## Construction of a Jet A-1 Transfer Pipeline and Tank Farm

(Bid No. B/21/2025)

## Answers for the clarifications sought by bidders - set 02

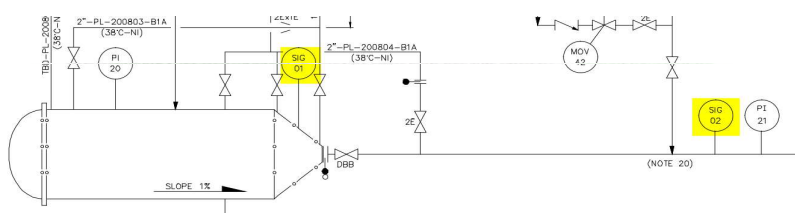
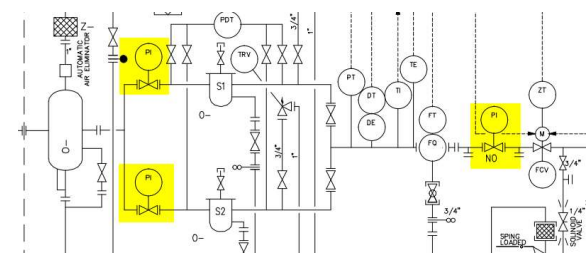
Sl. No.	Section	Reference Clause No./Section	Description	Bidder's Query	Response from CPC
9	Section V_Part (B)_PMN-117258-040_SOW_for_Tank_Farm	9.23Cathodic Protection of Internal 16-inch Pipeline	CONTRACTOR based on the conclusions of the checking and reviews of the FEED Cathodic Protection (CP) documentation and upon receiving the OWNER'S notice for agreement on the review results and recommendations, shall proceed with the production of specific to PROJECT Cathodic Protection (CP) design study for the internal 16-inch pipeline.	For 16 inch pipeline cathodic protection, there is no clear way required in ITB,so we suggest to use sacrificial anode ,please confirm.	Underground pipelines shall be protected using a suitable CP system.
10	7258-1831_1	2 general	Coating materials shall be certified by an accepted by OWNER internationally reputable independent testing institute according to the data sheet attached to this Specification (ATTACHMENT 1).	This specification does not provide Attachment A. For the field joint coating of the pipeline, please clarify whether to use polyethylene heat shrinkable sleeve material or the Cold wrap tape material as required by this document.	Heat shrinkable sleeve material should be used for the field joint coating.  Please refer the page 18 for the Attachment 1 in 7258-1831_1 in Part 2, Appendix 13

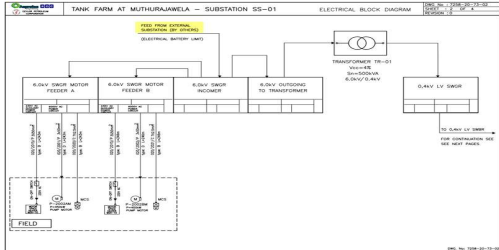
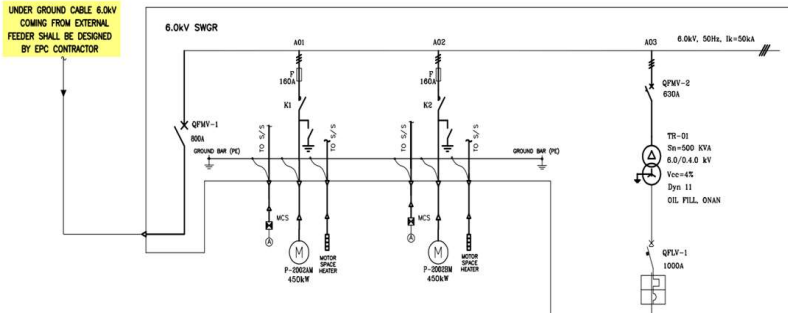
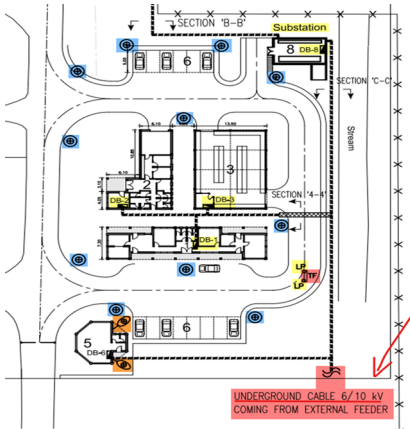
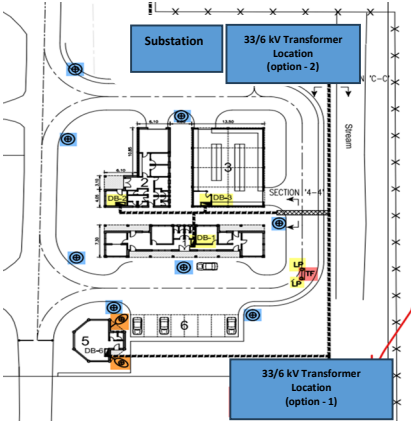
Sl. No.	Section	Reference Clause No./Section	Description	Bidder's Query	Response from CPC
21	P&ID no. 7258-30-50-60	Tie-in		please explain more details of the sentence as highlighted in yellow at tie-in point. Bidder understands that only MOV will be installed at tie-in. What does the flow measurement system mean?	Clamp-on type Ultrasonic interface detection flow meter or similar system shall be installed by the EPC/Turkey Contractor. Interface detection with flow measurement is intended here to minimize product downgrading during operation as this is a multiproduct pipeline which will be used for offloading of ocean tankers supplying multiple products (Diesel and Jet A-1).  <b>Interface detection accuracy:</b> *Capable of detecting product changeovers (e.g., Jet A-1 → diesel/petrol) with accuracy of ±1 to 3 meters of pipeline length.  *Sufficient for ensuring segregation and avoiding Jet A-1 contamination.  <b>Recommended Vendors :</b> Emerson, Siemens, Endress+Hauser, Baker Hughes or equivalent European, US
